INFORMATION REQUEST

APPLICATION NO: COM/77/2023
PROPERTY ADDRESS: 62-84 AND 86-108 TALINGA DRIVE, PARK RIDGE QLD 4125
PROPERTY DESCRIPTION: LOT 3 RP 131003, LOT 4 RP 131003
APPLICATION DESCRIPTION: COMBINED APPLICATION

- VARIATION REQUEST;
- RECONFIGURING A LOT (2 LOTS INTO 89 LOTS); AND
- OPERATIONAL WORKS FOR VEGETATION CLEARING

Figure 1: Excerpt from COM/10/2022 structure plan

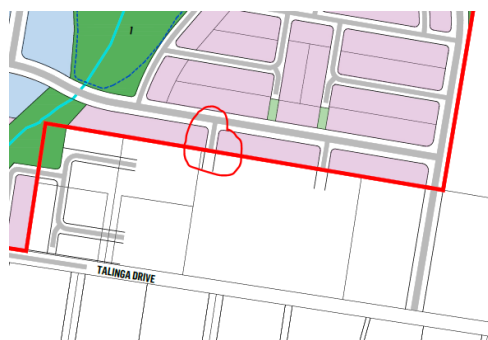
- 3.2. Amend the plans of development to include the second connection to the north as shown on the COM/10/2022 proposed structure plan (see **Figure 1: Excerpt from COM/10/2022 structure plan** below), ensuring that both connections align with the future road network proposed by COM/10/2022.
